**CITY OF DUNDAS PLANNING COMMISSION
PUBLIC HEARING AND SPECIAL MEETING AGENDA
TUESDAY MAY 31, 2022
6:30 PM – DUNDAS CITY HALL**

RE: Dundas – Stoneridge Second Addition - Preliminary Plat

Re: Stoneridge 2nd Addition Engineering Review
WSB Project No. 010168-000

CONCEPT/PUD

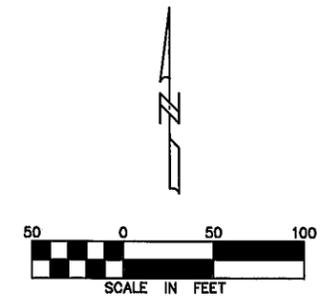
Additionally, the plan is being modified to remove the medians on Mill Towns Road and Stoneridge Parkway. At minimum City Staff recommended that there should be transitional medians from the first phase (where medians were installed) in to the second phase.

At the concept plan review, there was discussion about the design of the intersection of Mill Towns Road and Stoneridge Parkway. The proposed design includes a transitional median on Mill Towns Road but nothing on Stoneridge Parkway. The Planning Commission should review and comment on this configuration.

SITE PLAN
STONERIDGE HILLS 2ND ADDITION
 DUNDAS, MINNESOTA

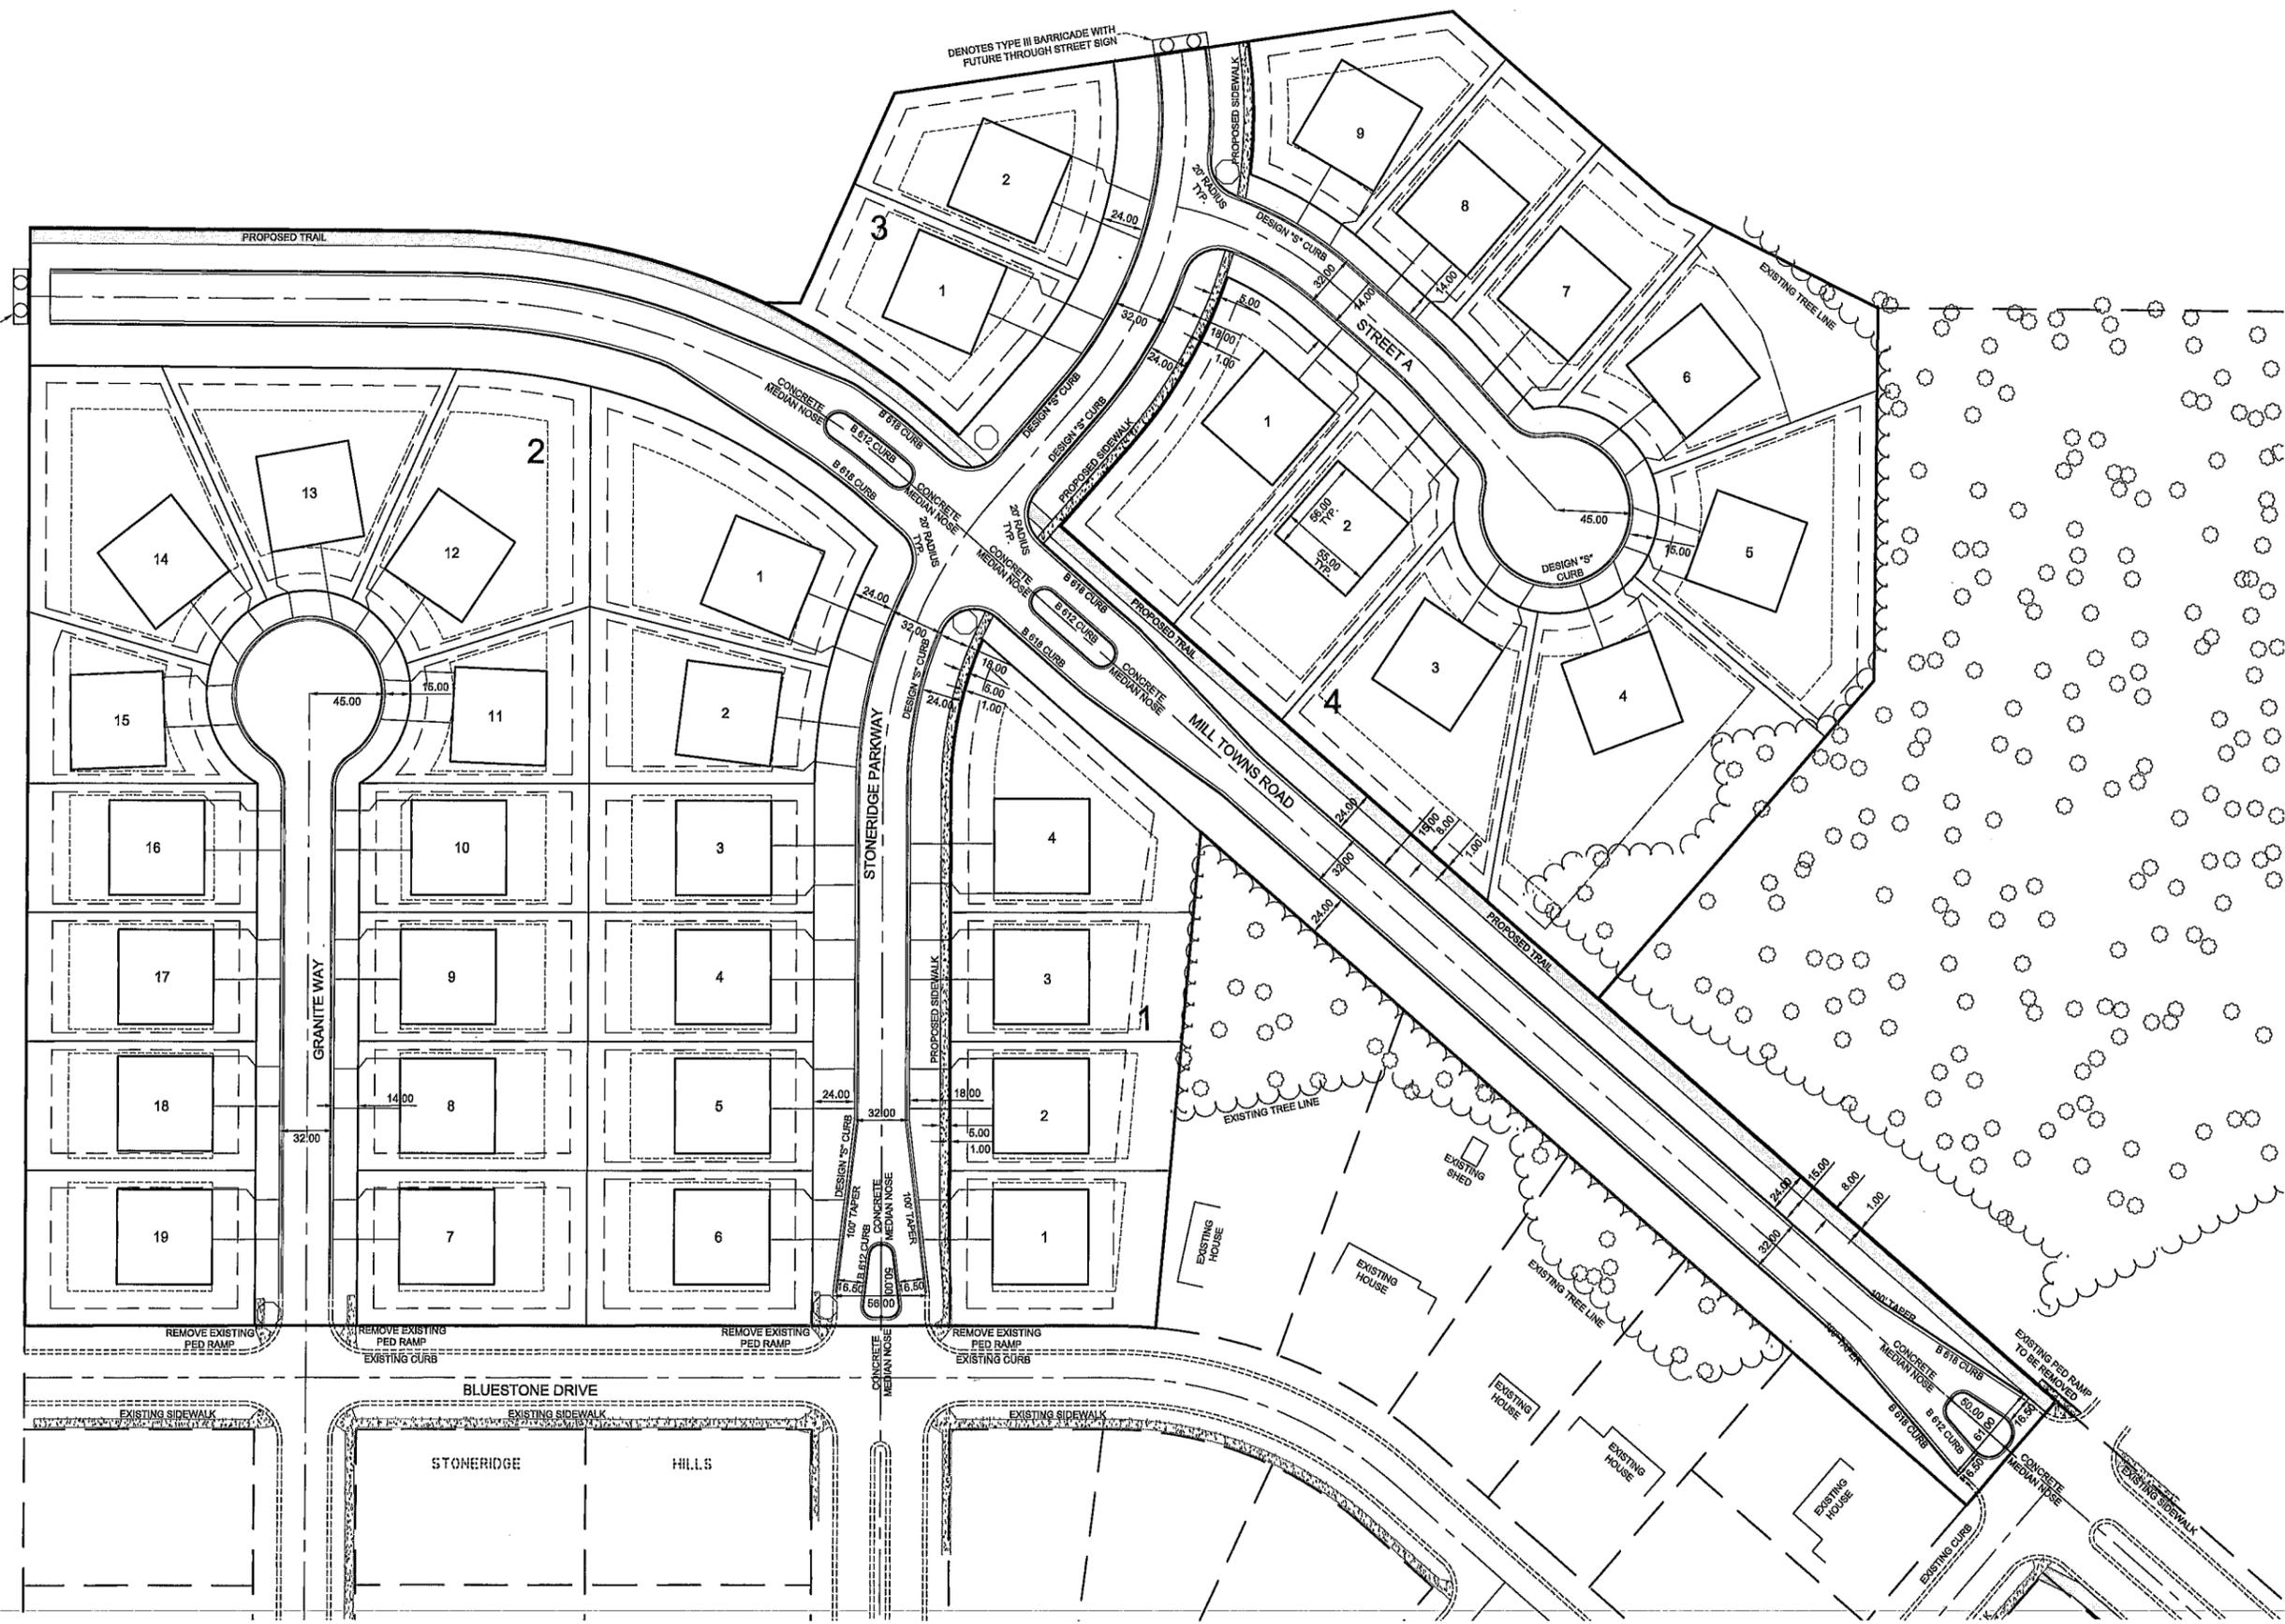
1. Extend Mill Towns Road to the western development limits
2. Install medians as shown in the concept plan along Mill Towns Road at the intersection with Bluestone Drive

3. Update the locations and extents of existing and proposed sidewalks and trails.
 - a. Show the existing sidewalk on the south side of Bluestone Drive west of Granite Way to the western development limits (to remain)

- b. Show the existing ped ramps on the north side of Bluestone Drive at Granite Way
 - i. Show as removing with project
 - c. Remove the existing ped ramp at the northwest corner of Stoneridge Parkway and Bluestone Drive

- i. Show the existing ped ramp at the northeast corner of Stoneridge Parkway and Bluestone Drive as remaining
 - d. Show the proposed 5' concrete sidewalk on the northeast side of Mill Towns Road as an 8' bituminous trail from the connection at Bluestone Drive to the western development limits

- e. Several existing ped ramps and sidewalk stubs are not proposed to have sidewalk extended from them.
 - f. There are existing ped ramps and sidewalk stubs at the northeast and northwest corners of Granite Way and Bluestone Drive that are not shown

- g. Show all new proposed ped ramps

- i. All ped ramps to meet ADA requirements
 - ii. Show the proposed ped ramps at the northeast corner of Stoneridge Parkway and Mill Towns Road as being merged
4. With future submittals include
 - a. Include any proposed signage and striping
 - b. Include any proposed lighting
5. Provide proposed curb type for Granite Way
6. Shift Type III barricades with future street signs to the leg of the nearest intersection
7. Show dimensions of street on either side of the medians (minimum 16' face to face) at the intersection of Stoneridge Parkway and Mill Towns Road
